Addendum 01

PROJECT: Jennings County Entrance Security Renovations
34 West Main Street
North Vernon, Indiana 47265

PROJECT #: 25064.00

This addendum form is a part of the Contract Documents and modifies the Construction Documents dated March 26, 2026, with amendments and additions noted below.

SHEET NUMBER:
BC-A1.1

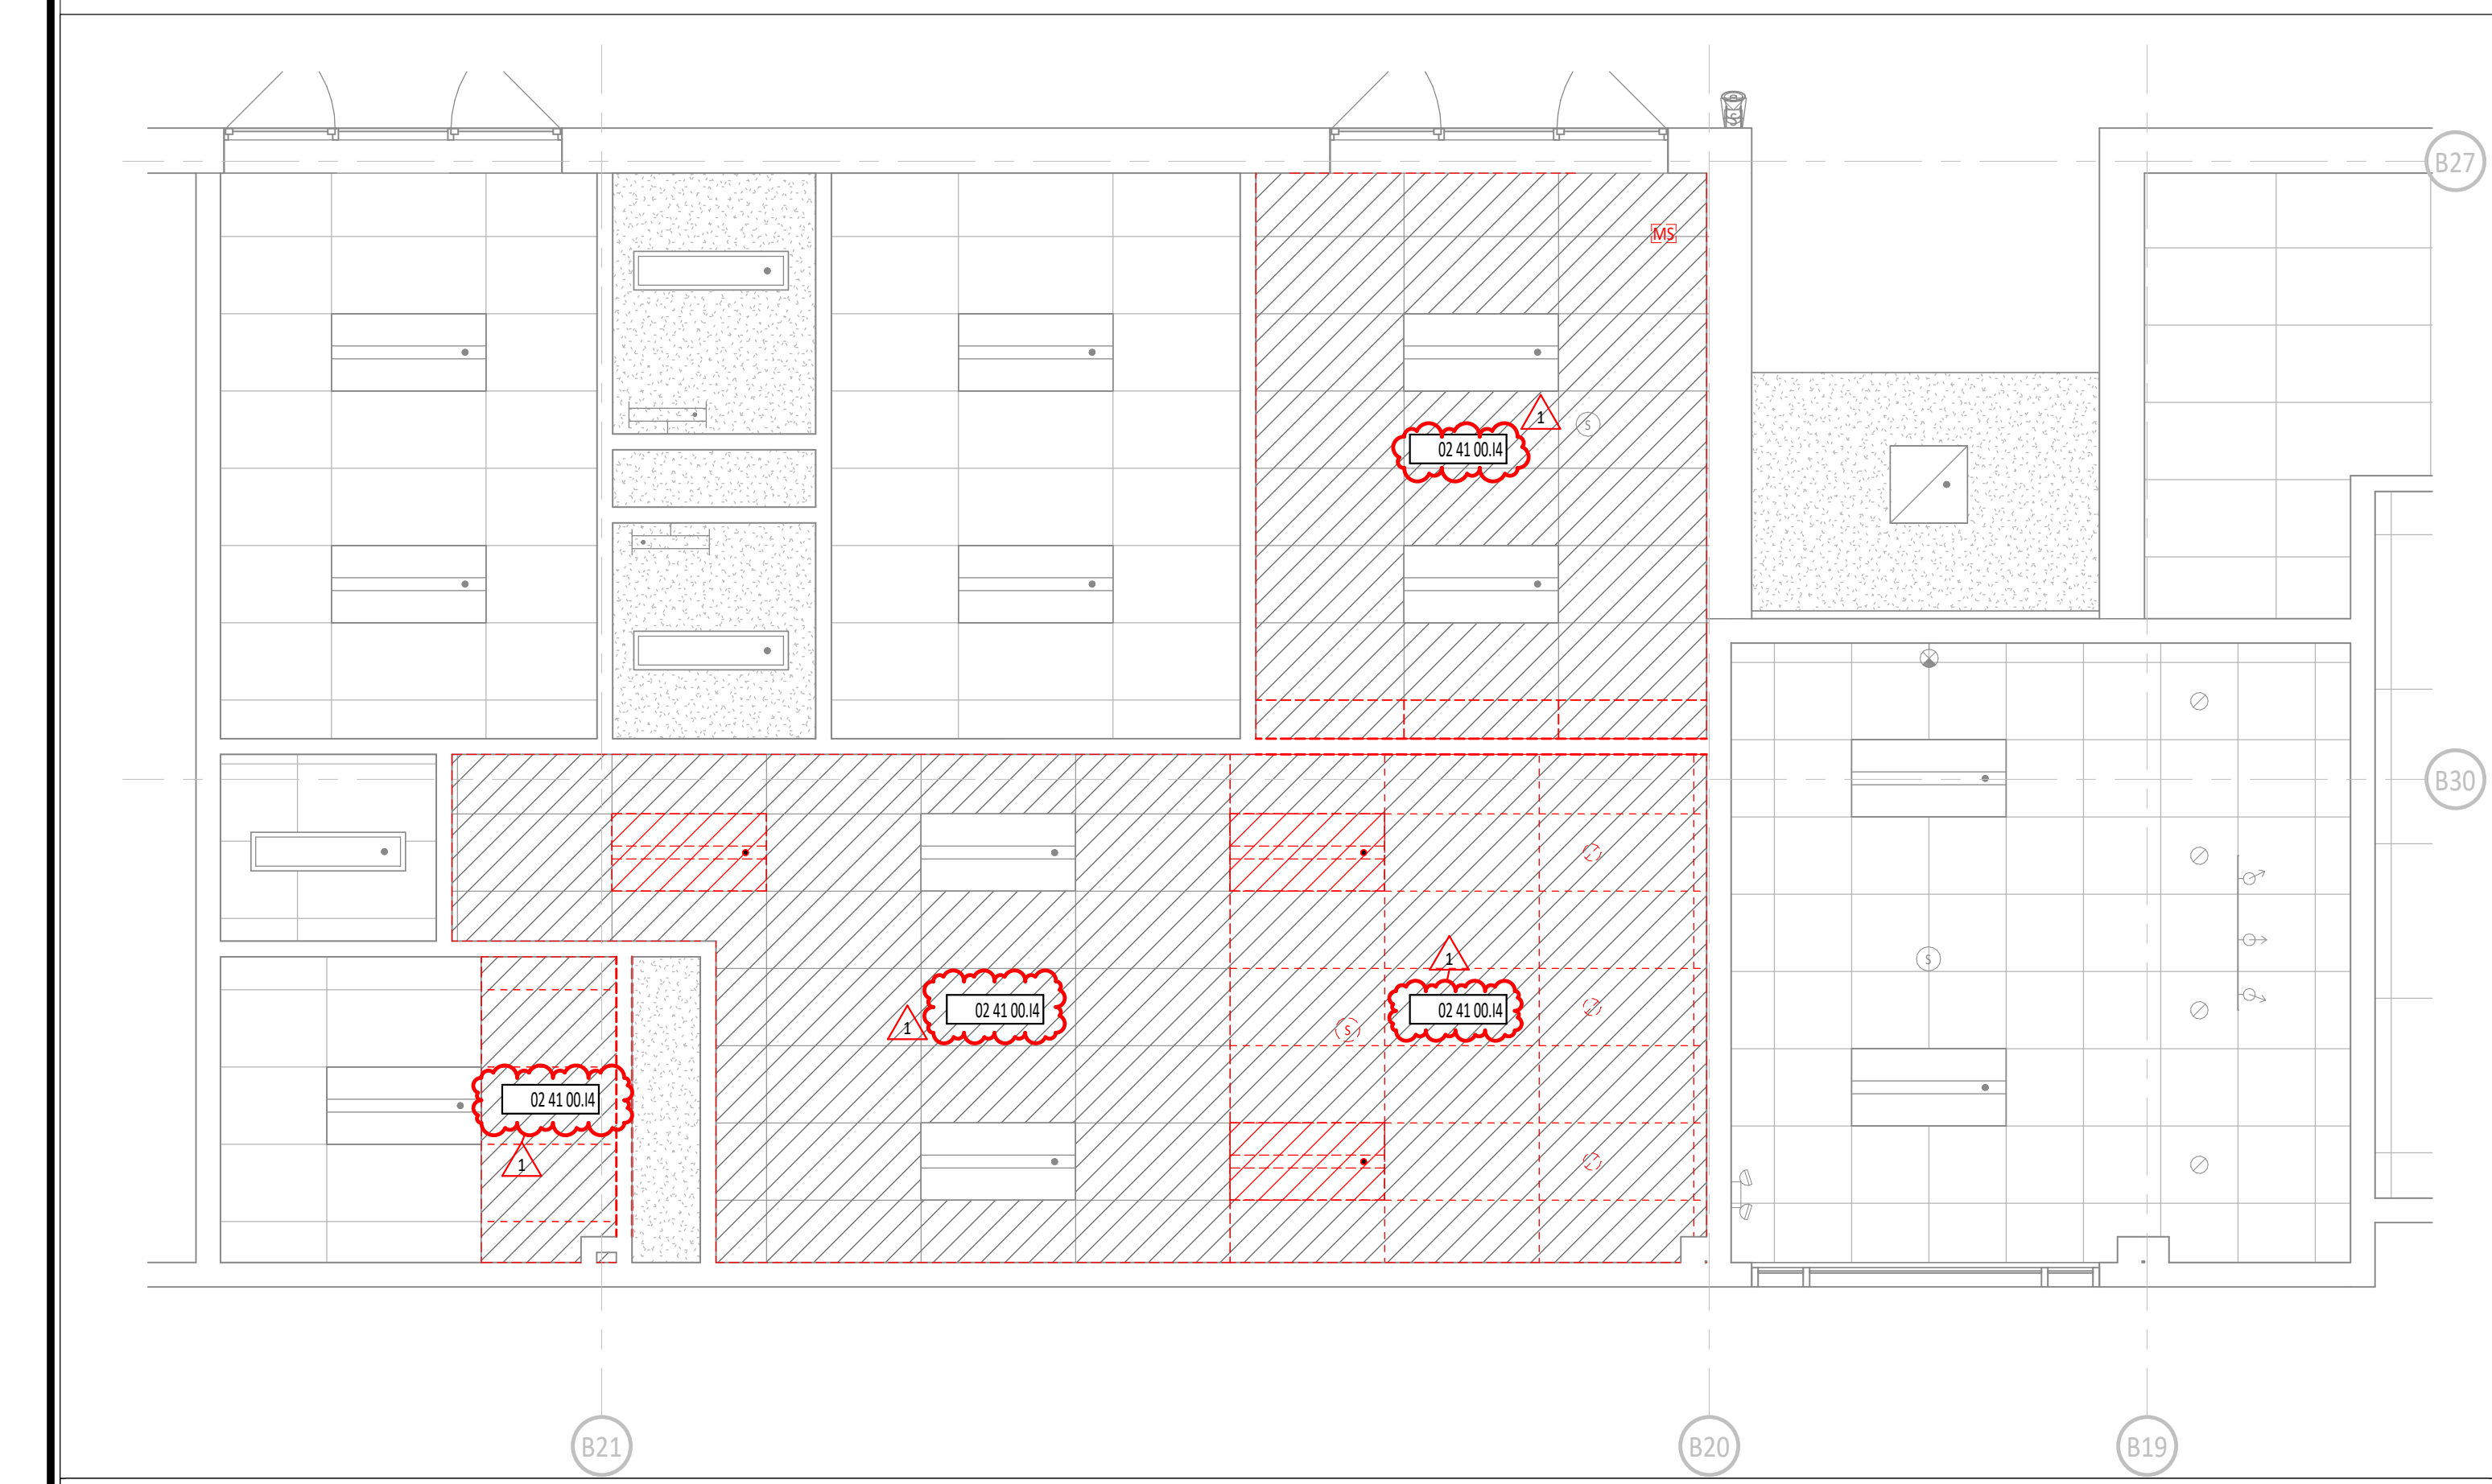
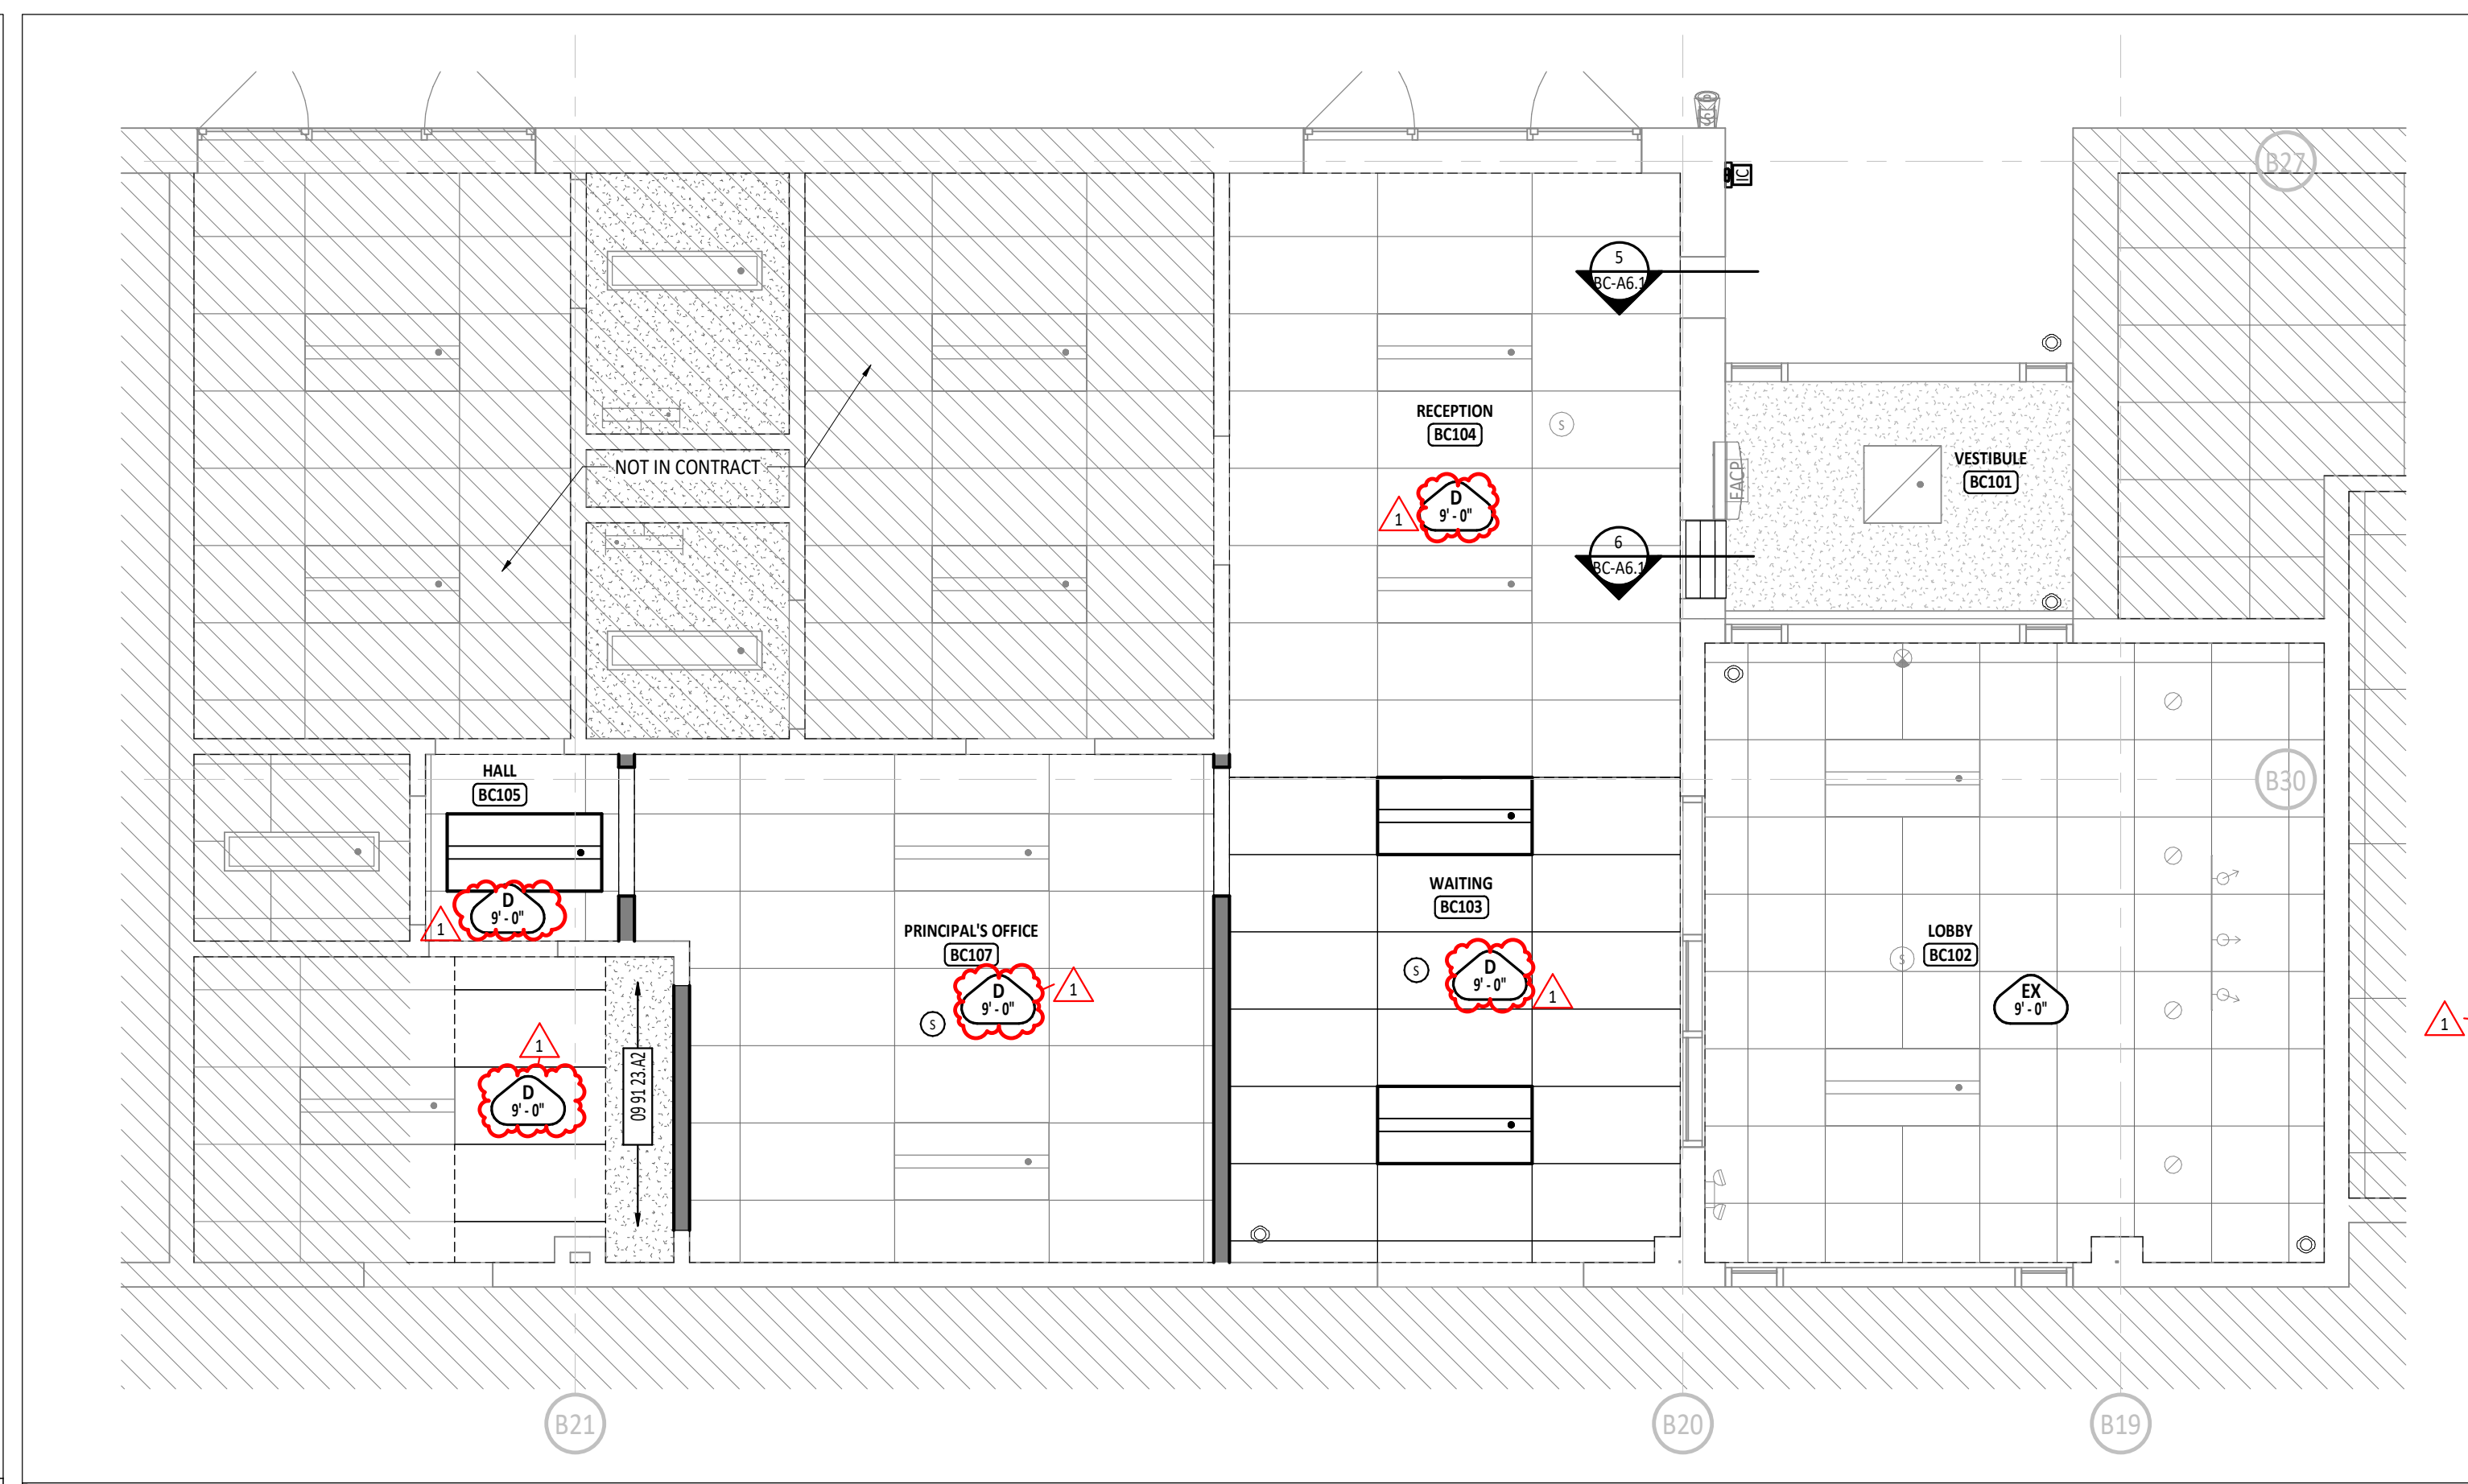
1. Drawing Sheet BC-A1.1 Architectural Plans
 - a. Revise ceiling demolition notes to keynote 02 41 00.14
 - b. Revise all ceilings as shown in detail #4 to by type D.
